1957 - 1958 Corvette: Service News: Corvette 4-Speed Transmission - Harsh Shift Into Third Speed

Source: Chevrolet Service News

Date: December, 1957

Subject: Corvette 4-Speed Transmission - Harsh Shift Into Third Speed

Fig. 3--Checking Third Speed Gear

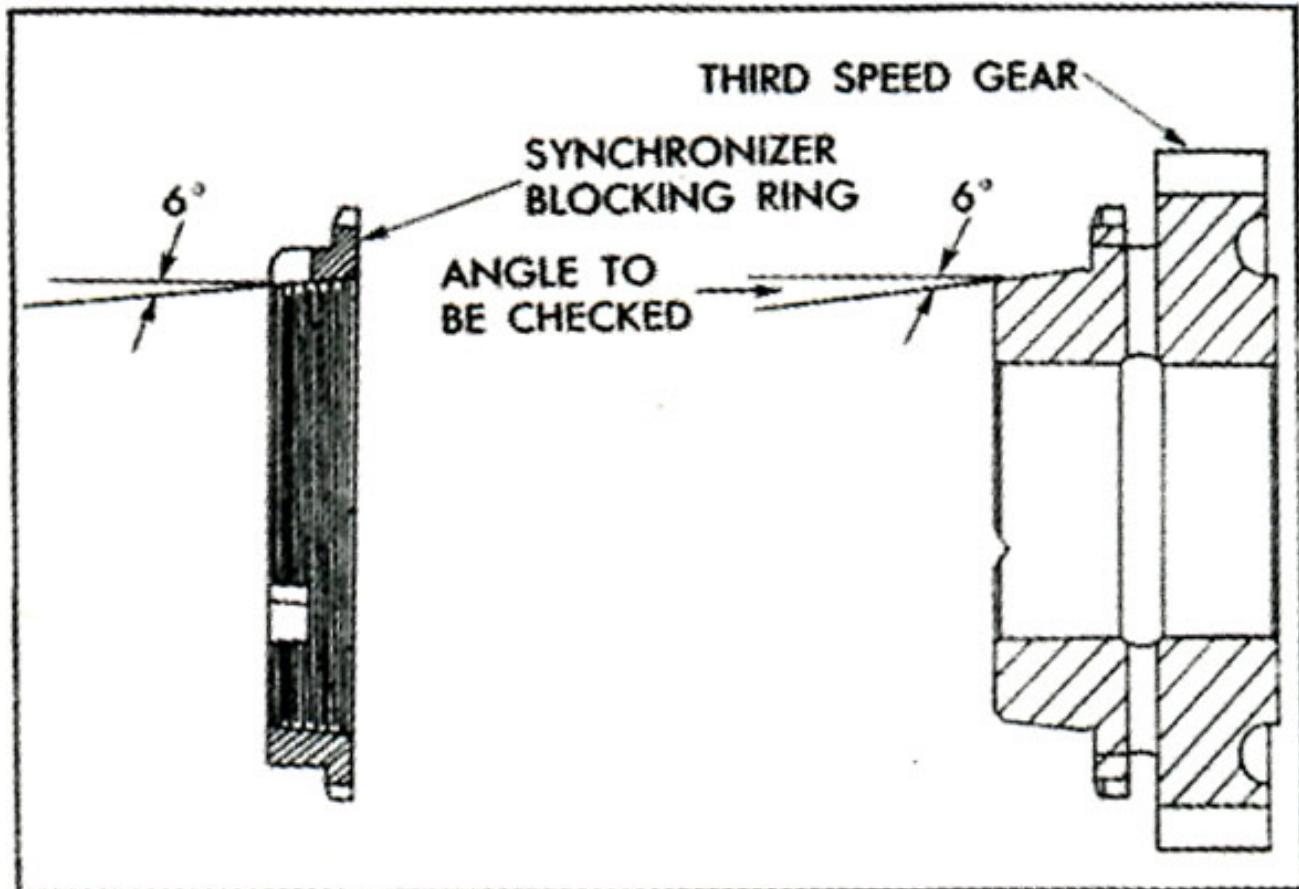
Some 1957 and 1958 Corvette four-speed transmissions have been built incorporating a third speed gear with 7° cone angle rather than the specified 6° , as illustrated in Figure 3. This may cause a harsh shift into third speed due to the resultant improper engagement of the synchronizer blocking ring and third speed gear cone.

The suggested correction, if the harsh shift is encountered, is to replace the third speed gear assembly No. 3743452 and the synchronizer blocking ring No. 3709348.

1. Coat I.D. of blocking ring lightly with a dye such as Prussian Blue.
2. Carefully install the blocking ring on the third gear cone to obtain an engagement impression.
3. If the Prussian Blue impression on the cone is all at the rear (or predominantly at the rear) the cone angle can be assumed to be 7 ° and should not be used. If the Prussian Blue is more or less evenly distributed on the cone surface, the angle is correct.
